Modifications by C.A. Meyer &  
 G. Wilkins.

CDC HVB Layout  
 Sketch #2  
 October 08, 2009

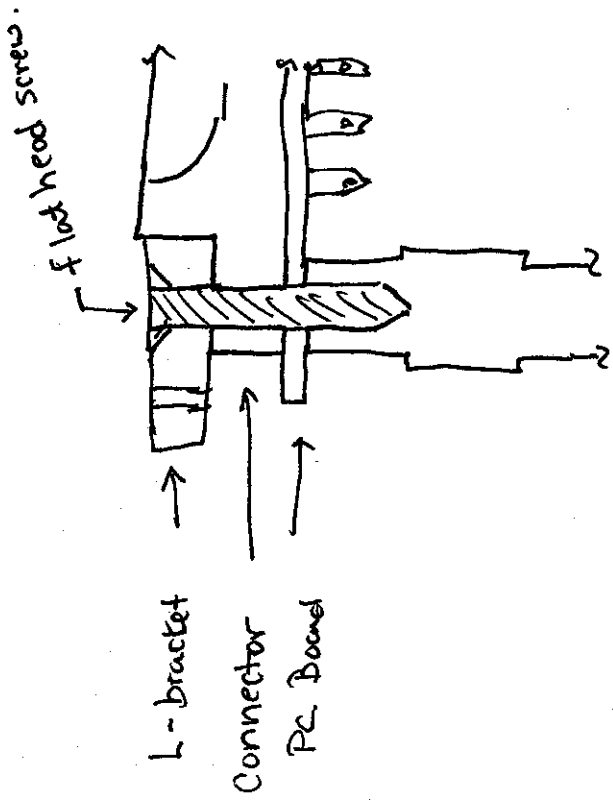
- (1) P.C. Board has plated ground  
 Connector on underside around  
 Screw hole.

- (2) L-bracket locks into position against the connector.
- (3) Ground is direct from P.C. Board to stand-off to end plate.
